Access Compliance Report Public Rights-of-Way (Curb Ramps)

Main Street: SUBURNAS_WY		Cross Street: FOOTHILL_BLVD		Location:	W
ADA ID: RPAT211018085114	Ramp Type: Type 6 - Directional 1	Initial Pass/Fail: Pass	Overall Compliance: No	Severity Score:	9
Codes/Mitigation Info/Possible Solution			Field Measurements/Component Compliance

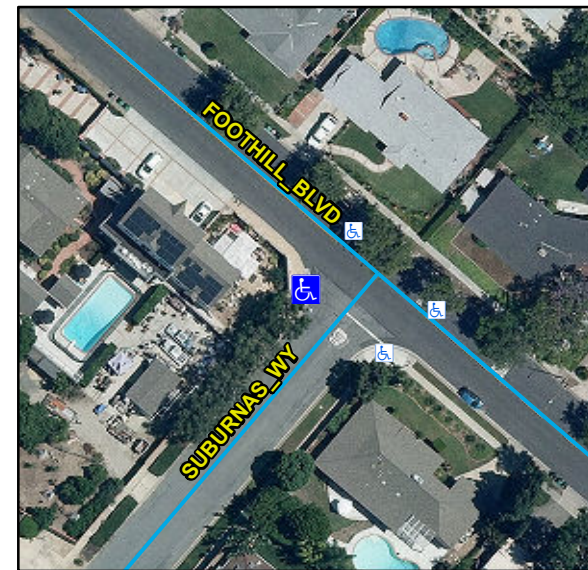
R304.2.2, R304.2.1, R304.5.3, R304.5.4, STD 1115

Remove & Replace Curb Ramp With Two New Directional Ramps or Equivalent. Remove & Replace Gutter.
